Working Party on Lighting and Light-Signalling (GRE)  
(~~Fiftieth session, 07 April—11 April 2003,~~  
~~agenda item 3.2.~~)

PROPOSAL FOR DRAFT AMENDMENTS TO REGULATION No. 48

(Installation of lighting and light-signalling devices)

Transmitted by the Expert from the Working Party "Brussels 1952" (GTB)

*Apparent surfaces of lighting units 1 through 11 of an AFS (example)*

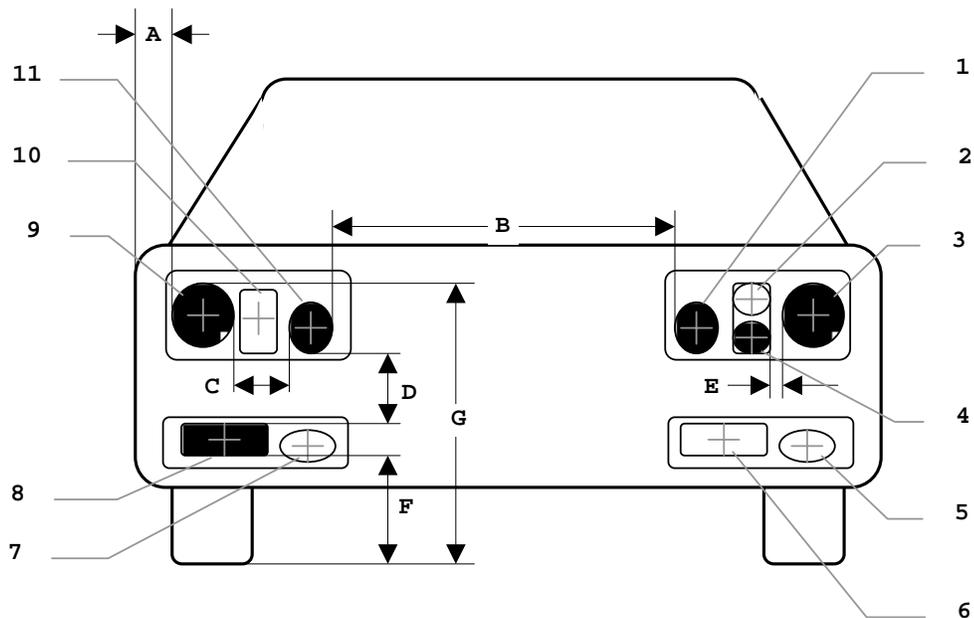
6.20.4.1.1. *Two symmetrically placed lighting units shall be positioned at a height in compliance with the requirements of the relevant paragraphs 6.1.4. and 6.2.4.,*

***where "Two symmetrically placed lighting units" shall be understood to be two lighting units, one on each side of the vehicle, positioned such that the (geometric) centres of gravity of their apparent surfaces are at the same height and at the same distance from the vehicle's longitudinal median plane within a tolerance of 50 mm, each; their light emitting surfaces, illuminating surfaces, and light outputs, however, may differ.***

6.20.4.1.2. *Additional lighting units, if any, on either side of the vehicle shall be positioned at a distance not exceeding 140 mm z/ in horizontal direction (E in the figure) and 400 mm in vertical direction above or below (D in the figure) from the nearest lighting unit;*

6.20.4.1.3. *None of the additional lighting units described in paragraph 6.20.4.1.2. above shall be positioned lower than 250 mm (F in the figure) nor higher than [ 950 /1200 /1500 ] mm (G in the figure) above the ground;*

*the outer edge of the apparent surface of at least one lighting unit on each side of the vehicle shall not be more than 400 mm from the extreme outer edge of the vehicle (A in the figure); and,*

*the distance between the inner edges of the apparent surfaces of the lighting units on the right and left hand side of the vehicle (B in the figure) shall be not less than 600 mm, or, except for category M<sub>1</sub> and N<sub>1</sub> vehicles not less than 400 mm when the overall width of the vehicle is less than 1300 mm.*

- No.3 and 9: two symmetrically placed lighting units
- No.4 and 8: two additional lighting units
- No.1 and 11: two symmetrically placed lighting units

- $A \leq 400$
- $B \geq 600$  or  $\geq 400$  if vehicle overall width  $< 1300$  mm, however  
no requirement for category M1 and N1 vehicles
- $C \leq 200$
- $E \leq 140$

- $D \leq 400$
- $F \geq 250$
- $G \leq [ 950 / 1200 / 1500 ]$
